ADDENDUM 1 – JOB 39

TO: All prospective bidders on project SOIB-CPU-7-023(050)910, Job No. 39 scheduled for the November 17, 2017 bid opening.

**ADDENDUM 1
JOB NO. 39**

TO: All prospective bidders and suppliers on Project SOIB-CPU-7-023(050)910, Job No. 39 in McKenzie County, scheduled for the November 17, 2017 bid opening.

Revised	10/31/17	STATE	PROJECT NO.	SECTION NO.	SHEET NO.
		ND	SS-7-023(050)910	90	7

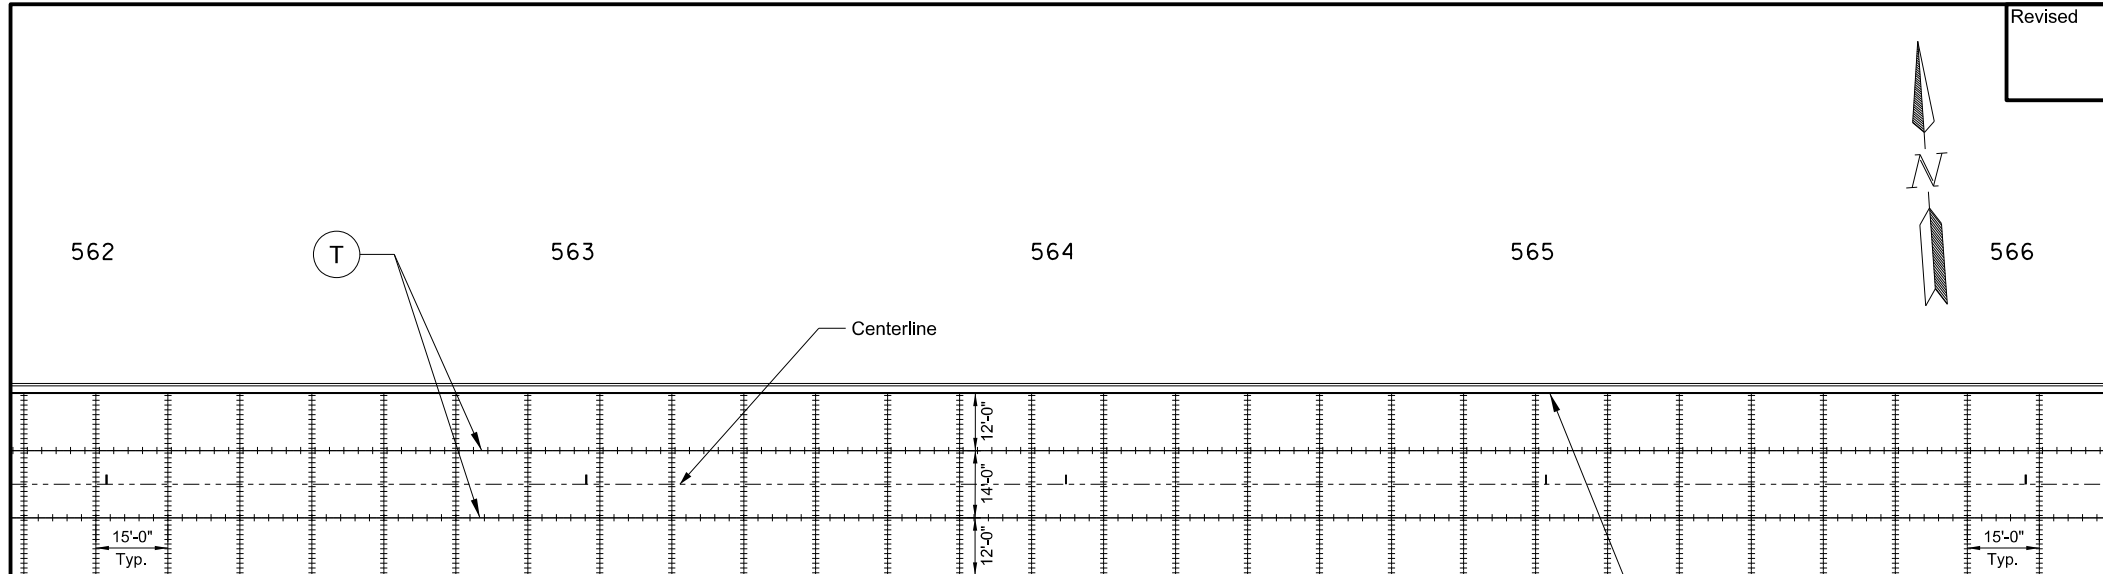
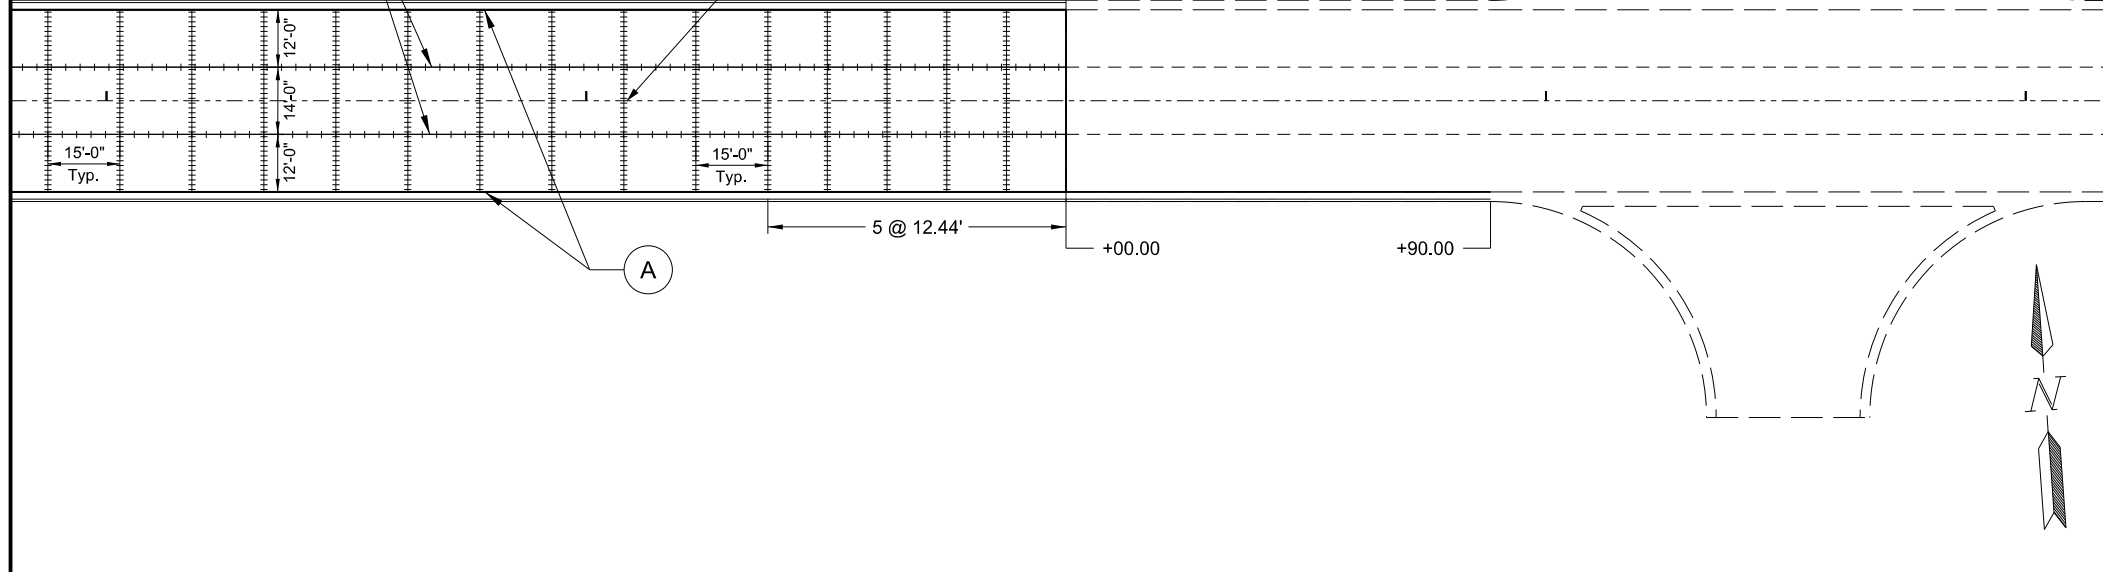
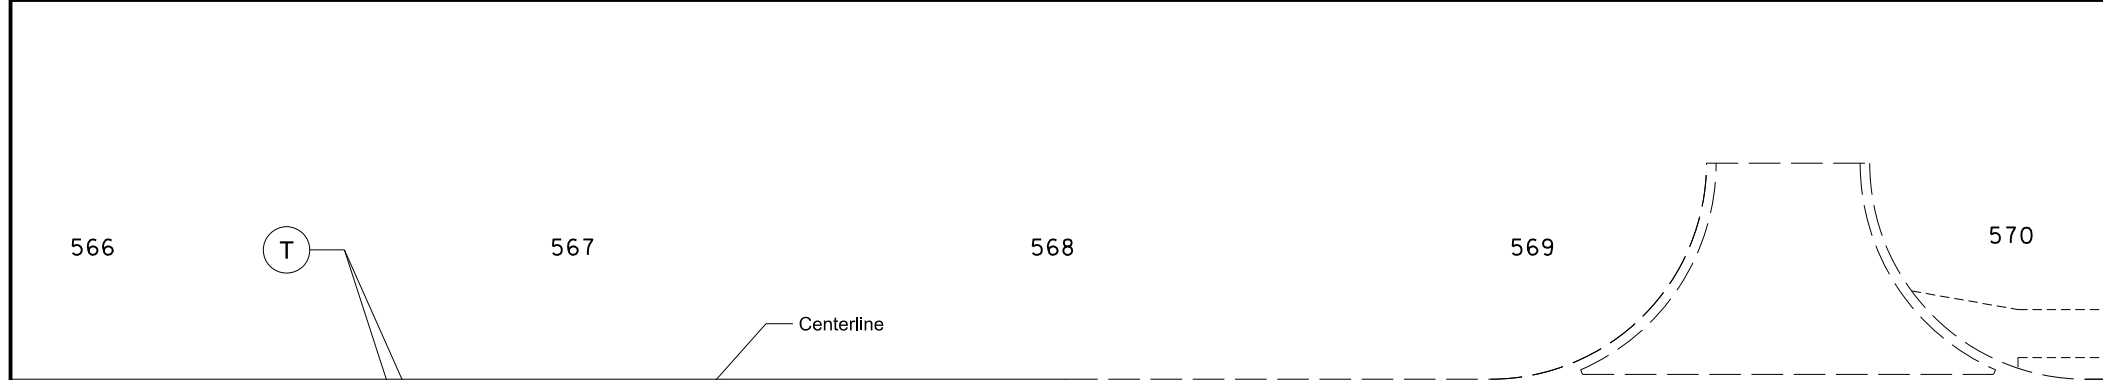
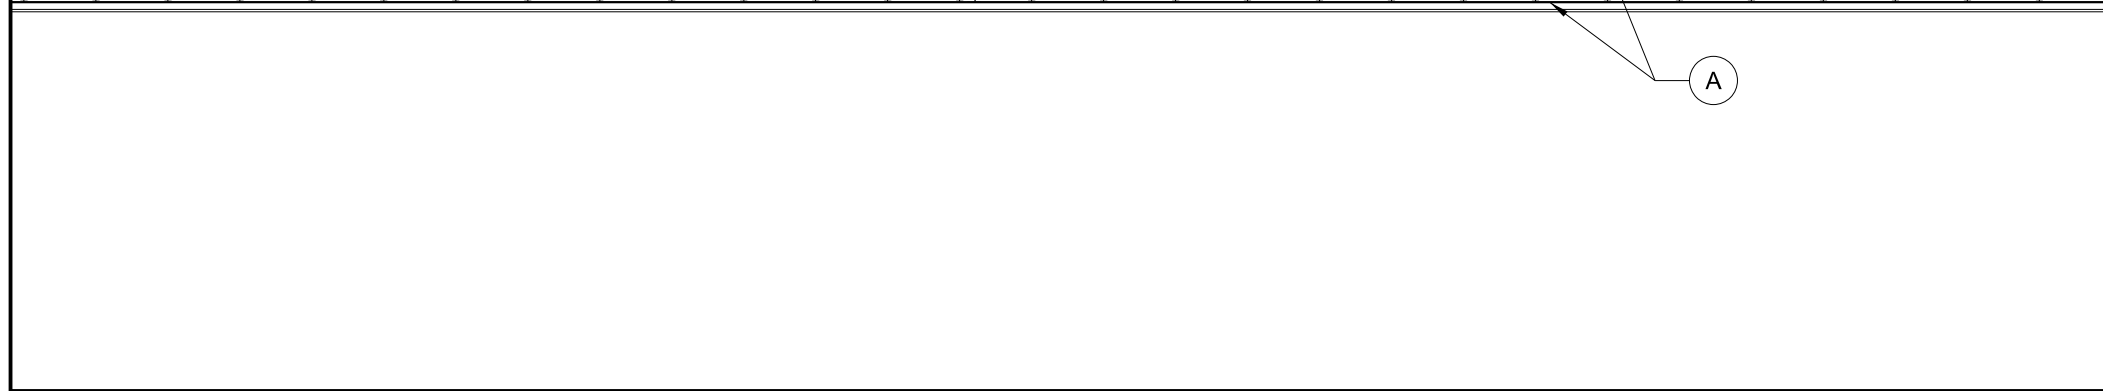
- Section 82, Sheet 2: The survey data for the temporary bypass was updated.
- Section 90, Sheet 7: The installation limits and quantity for Curb & Gutter Type I were updated to accommodate the installation of the temporary bypass.

Revised	10/31/17	STATE	PROJECT NO.	SECTION NO.	SHEET NO.
		ND	SS-7-023(050)910	90	15

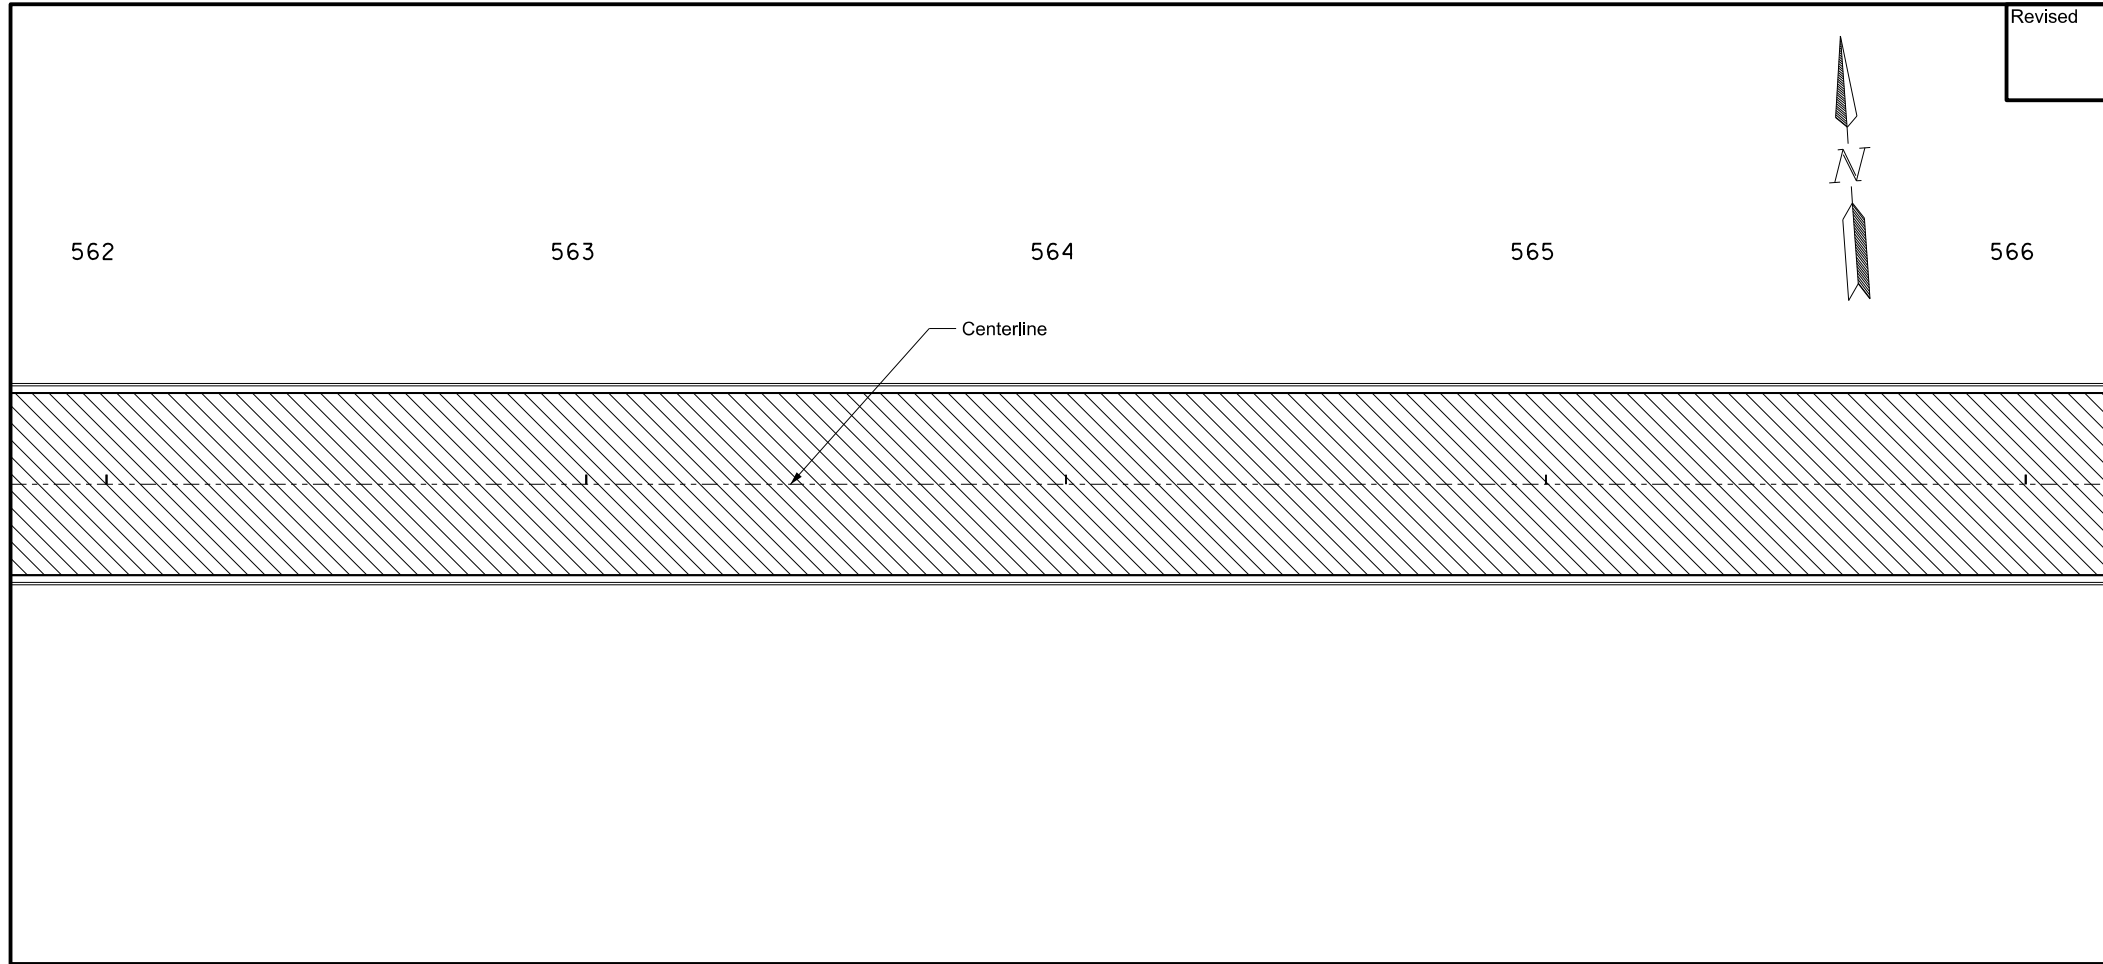
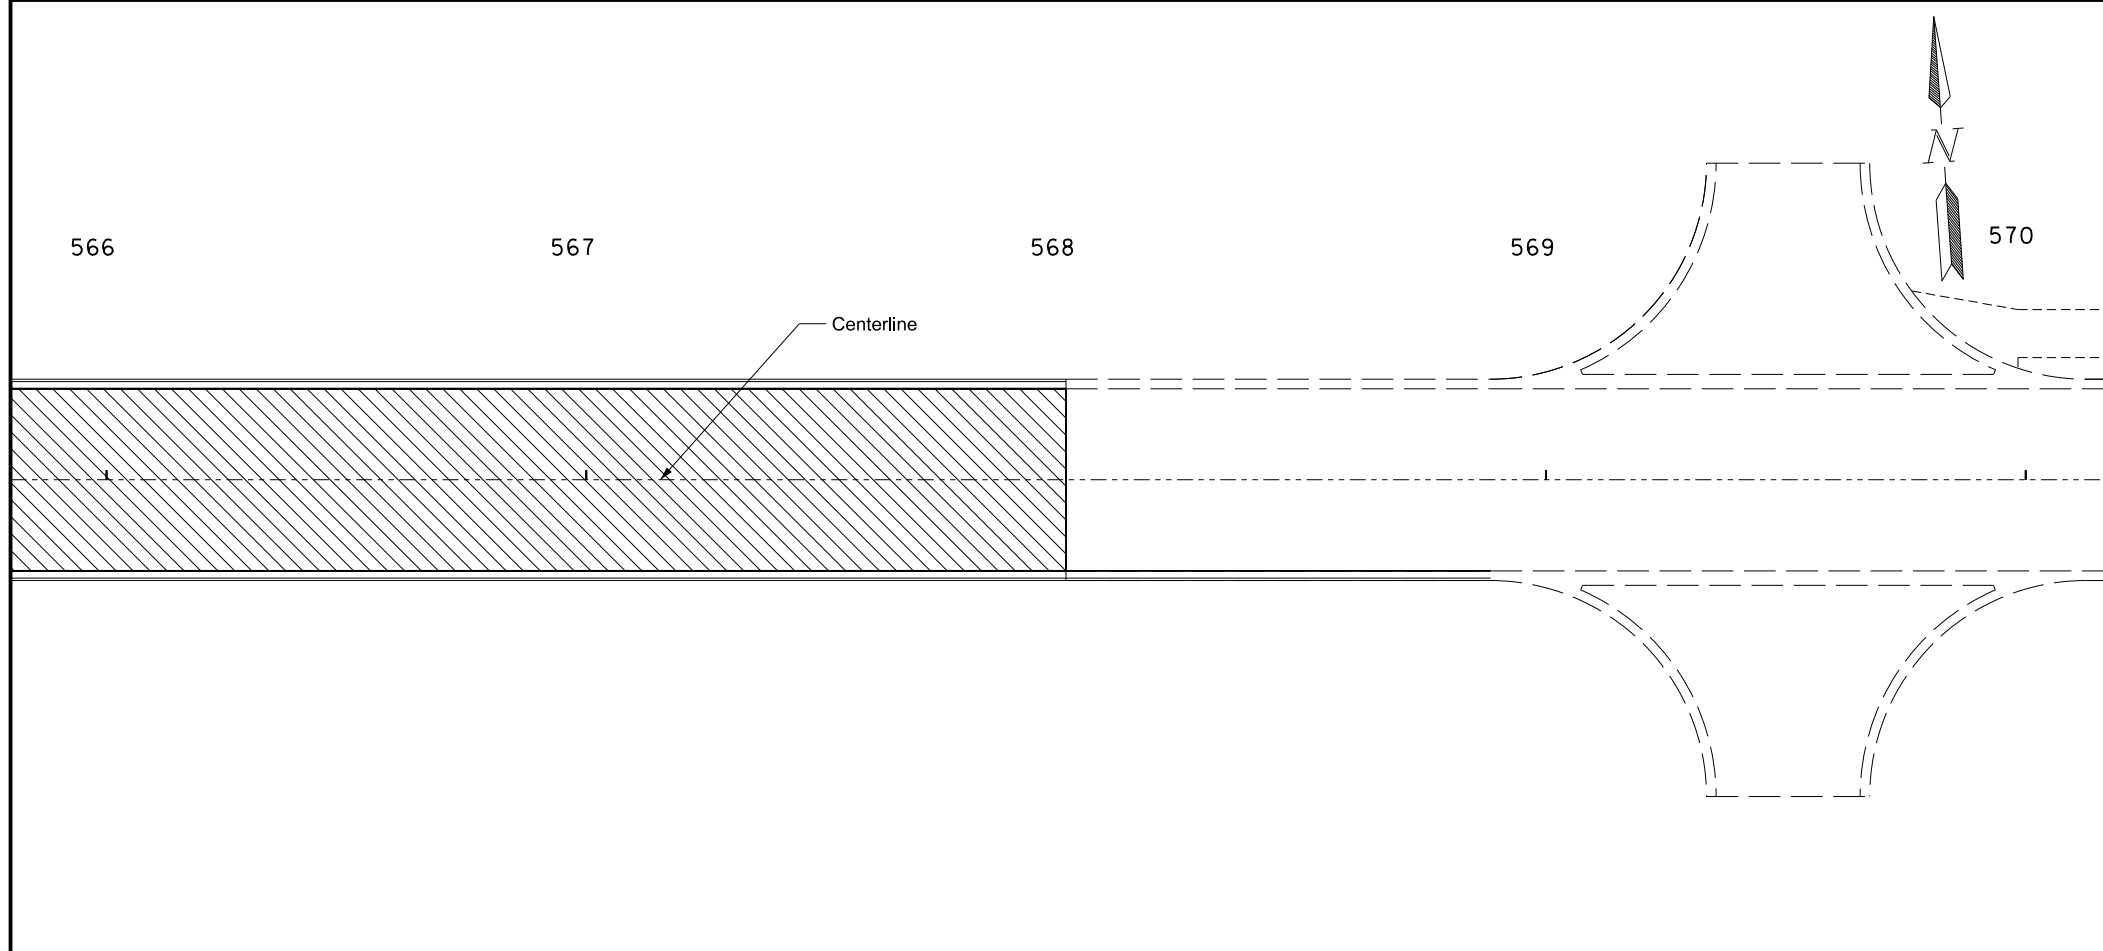
- Section 90, Sheet 15: The installation limits and quantity for Curb & Gutter Type I were updated to accommodate the installation of the temporary bypass.
